SUPPLEMENT NUMBER 1

PRELIMINARY SAFETY ANALYSIS REPORT

OYSTER CREEK UNIT #2

SUPPLEMENTAL FLOOD STUDIES
FOR
OYSTER CREEK NUCLEAR POWER PLANT
UNITS NO. 1 and NO. 2

WIND SETUP SECTION
BARNEGAT BAY

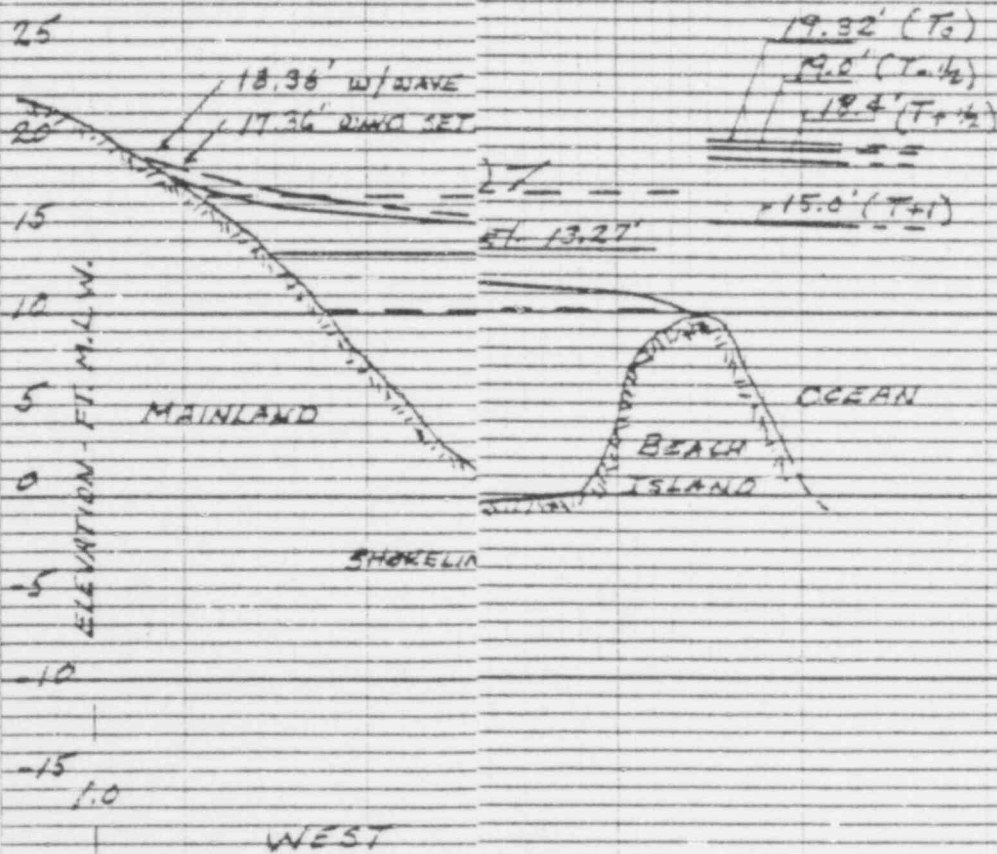
- d. It is not apparent from the text of the Unit 2 PSAR that an additional pile up of water within the bay was considered at the mainland shore in the vicinity of the site due to wind stress acting on the free water surface of the bay. This water pile up would give an additional setup of the surge. This effect should be considered in your evaluation using the method of computing the bay surge coupled to the open coast surge presented in "Numerical Model for Storm Surges in Galveston Bay," by Reid, R. O. and Bodine, B. R., Journal of the Waterways and Harbors Division, ASCE, Vol. 94 No. W.W. 1, Proc. Paper 3805, February, 1968.

the magnitude of local wind effects across the bay from $T-\frac{1}{2}$ to $T+\frac{1}{2}$ hours a 2-mile wide bay section was used, as shown on Exhibit 1, attached. That section fronts the plant site and encompasses both discharge and intake channels, and is considered to be of sufficient width to be representative of average bottom elevations, wind speeds, wind setup, and wave action in the bay area fronting the plant site. An average ground and bay bottom profile was obtained for that section from available U.S.G.S. and C&G.S. topographic maps. That profile is shown on exhibit 2, attached. Ocean surge elevations and mean water surface elevations in the bay at $T-\frac{1}{2}$, T_0 , $T+\frac{1}{2}$ hours are also shown. Peak FM wind speeds across the section in that period would be on the order of 120 mph, with wind directions as shown by arrows on Exhibit 1. The problem of determining wind setup across Barnegat Bay is unique in that during the hour $T-\frac{1}{2}$ to $T+\frac{1}{2}$ the mean water level in the bay rises over 6 feet -- from 10.2 ft. to 16.4 ft. MLW, during which time wind stress on the bay surface is attempting to establish a steady-state setup condition. The "normal" boundary conditions relative to setup-setdown and surface-bottom flow relations, while still present, do not achieve stability in accordance with the classical concepts. Because of the rapidly changing water depths within the critical hour, from overflow and inflow to the bay, it is highly improbable that a true "steady state condition" can be expected to occur, or be attained in the bay. Therefore, in an effort to arrive at a "reasonable" estimate of the range in magnitude of additional pile up at shore due to wind stress across the bay in the period $T-\frac{1}{2}$ to $T+\frac{1}{2}$, computations were made using an "average" water

level in the bay for that period (10.10 ft. + 12.15 ft. + 2 = 13.27 ft. (M.S.L.)) with an average wind speed of 120 mph. The formula and procedures used are those derived in Ref. 5 and applied in Ref. 2 and 3. Trial and error estimates established the node line at approximately mile 1.3 East (see Exhibit 2). The computed setup elevation at the mainland shore, exclusive of wave effect, was determined to be 17.36 ft. M.L.W. (17.06 ft. M.S.L.). During the hour $T-\frac{1}{2}$ to $T+\frac{1}{2}$ the depth of water over the eroding beach dune would reach a maximum of about 3-9 ft. thus allowing waves of up to 6 feet height to pass over the dune. Some attenuation of wave length could result due to the overflow velocities but those waves reaching the bay would reform and be increased in wave height in moving across the bay. In general, it is estimated that an additional 1 foot of water due to the effect of waves breaking landward of the mainland shoreline should be added to the peak setup elevation, making a total PMW bay tide elevation of $\frac{17.36 \text{ ft.}}{\text{MLW}}$ (18.06 ft. MSL).
